Number: C0006      Date: 7/17/00      Supersedes: C9912A      Date: 6/6/99  
Title: Oil Pressure Alarms  
Category: *GENERAL*      Termination Date:  
Author: Steve Bayes  
Reviewed by: Alan M. Johnson  
Dept: CSS Service Engineering

Models: CAC: 19XR centrifugal chillers  
Affected: BDP:

To advise the field of two known problems relating to oil pressure alarms on 19XR centrifugal chillers with PIC II controls. This addendum describes the two problems, suspected root causes, and alternatives available for fixes.

Figure 1. Wiring Diagram for Capacitor Placement  
Addressing Low Oil Pressure

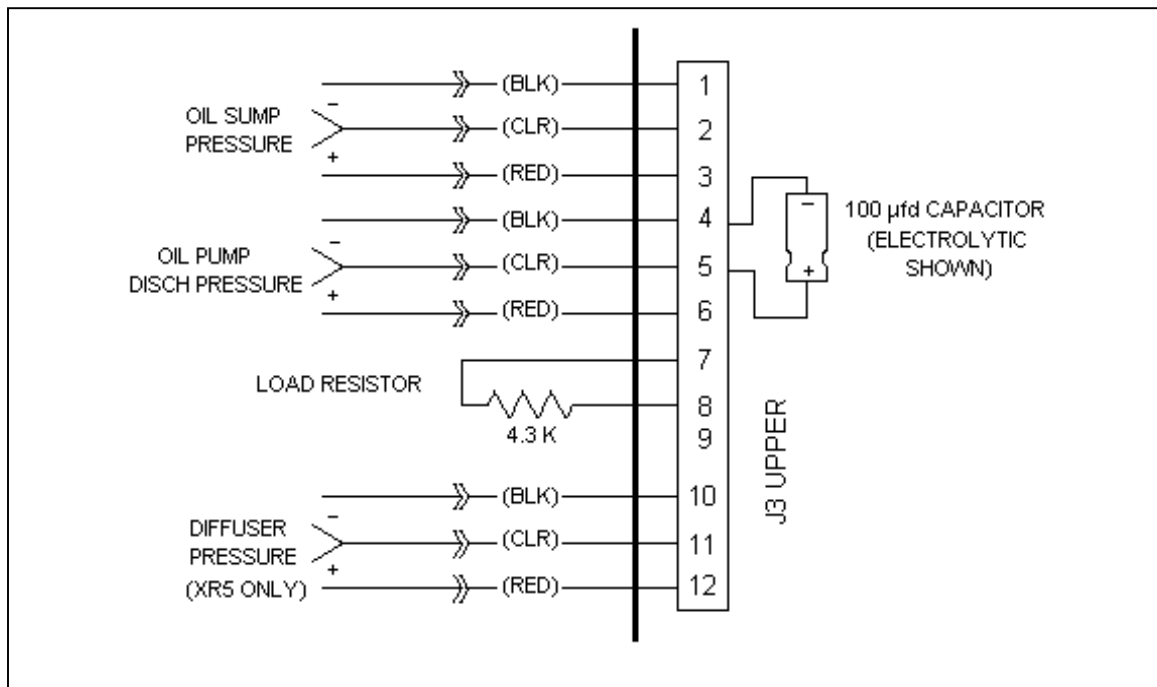
Machine shuts down in Alarm State 228, "Protective Limit - Low Oil Pressure" (pressure below 13 psi when machine is RUNNING and startup is complete).

There have been reports of 19XR chillers going down on a low oil pressure alarm, often soon after start up. Typically oil pressure of 24 to 28 psid is established during the pre-lube cycle. The chiller initiates a start, continues to operate through transition and then, anywhere between 30 to 90 seconds into the start, before the guide vanes start to open, it may go down on low oil pressure. The oil pressure loss has been observed in (at least) three forms:

1. The alarm is caused by a transient drop in oil pressure below the trip threshold. In some cases this may result from cavitation at the inlet of the pump. In other cases, variations in oil pump construction may result in significant high frequency pressure pulsations, the low point of which may drop below the alarm threshold, while the mean value is satisfactory. The PIC II controls are designed to recognize and respond to loss of oil pressure when the duration of the loss is a fraction of a second.
2. Gradual loss of oil pressure causes an alarm. In this case the decrease is slow enough to be observed and tracked on the CVC

display. After the chiller starts a small drop occurs down to about 21 psid, continues past the alert level of 18 psid to the alarm level of 15 psid where the chiller shuts down on low oil pressure.

3. The third form is a hybrid of the first two where after start up the pressure difference gradually decreases and then dips in a transient as described in number 1.

Corrective action is intended primarily to address the situation described in cases (1) and (3) above. On all 19XR chillers (or compressors) in which a problem with low oil pressure alarms arises, install a 100 microfarad capacitor, rated for 16 volts or higher, between terminals 4 and 5 on the upper J3 plug as shown in Figure 1 below. (If the capacitor is of the electrolytic type, with a + or - polarity indicated, attach the "-" end to J3-4.) The capacitor smoothes out the oil pump discharge pressure transducer signal without substantially affecting oil pressure sensing.

If this modification does not resolve your problem, please report the problem to Service Engineering so that other solutions can be discussed. The factory installed this capacitor on all 19XR chillers starting the first week of June, 1999.

Figure 2. Wiring Diagram for Capacitor Placement  
Addressing Both Oil Pressure Issues

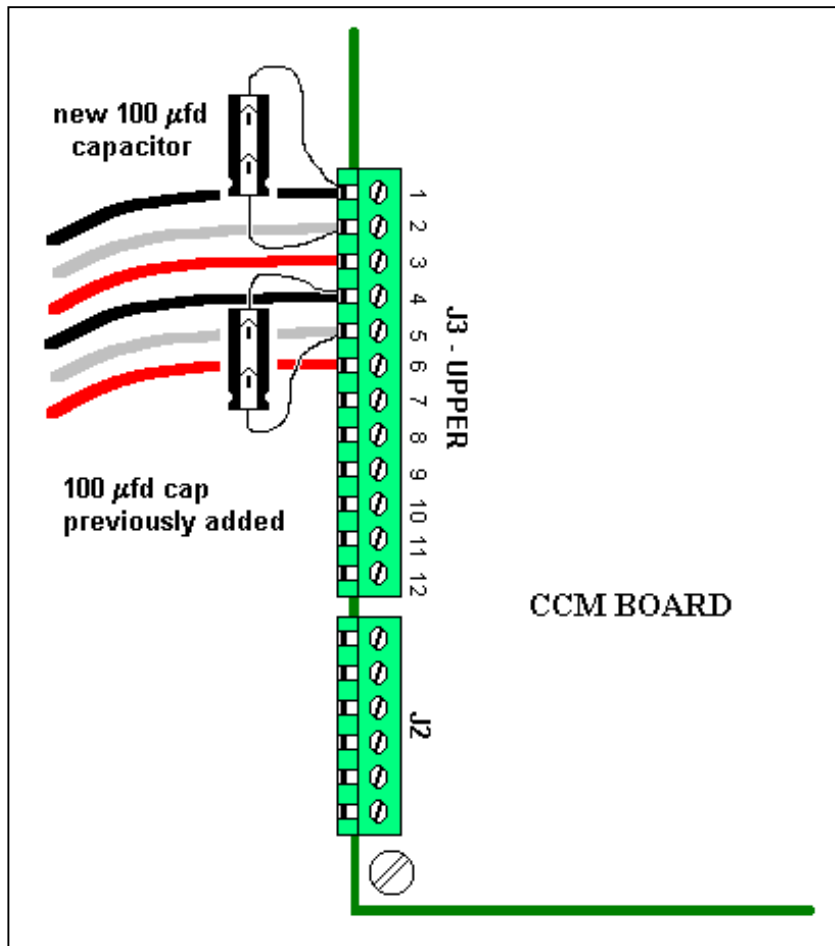
Alarm State 227, "Protective Limit - Oil Pressure Sensor Fault", is declared based on oil pressure exceeding 4 psi when the chiller and oil pump are OFF.

There have been numerous reports of 19XR chillers generating this alarm when the chiller is off. This has been linked to high frequency noise, marginal grounding of the CCM, and problems with the hardware and software filtering performed within the CCM. If you watch the oil pressure in the STATUS/COMPR screen on the CVC for several minutes, a "calm" reading (without the problem) will normally show a variation or bounce within a range of approximately 0.50 to 0.75 psi. If you have this problem you are likely to see greater variation, with a range of 2 psi or more within a span of 5 to 10 minutes.

1. Improve the grounding of the CCM, especially the sump oil pressure channel, to the chiller. Add a grounding conductor from J3-1 and/or one of the screws passing through a standoff (at any of the CCM's corners, for example) to one of the control panel's ground screws. Also assure that the control panel is well-grounded to the chiller itself.

2. Install [another] 100 microfarad capacitor, rated for 16 volts or higher, between terminals 1 and 2 on the upper J3 plug as shown in Figure 2 below (which also shows the capacitor added for the low pressure oil fault described above). If the capacitor is of the electrolytic type, with a + or - polarity indicated, attach the "-" end to J3-1. This capacitor will filter out high frequency noise (which may not necessarily be detectable with a standard voltmeter) on the input or on the CCM ground. These capacitors were installed on production units starting on or about May 1, 2000.

3. Upgrade the CVC to use Version 04 software (19XR) along with the OTP microchip Version 68 or 69. These were formally released for production in June, 2000. This software will check to see if oil pressure exceeds the 4 psi limit only for a 10-second window immediately before a startup, instead of continuously when the chiller is off.
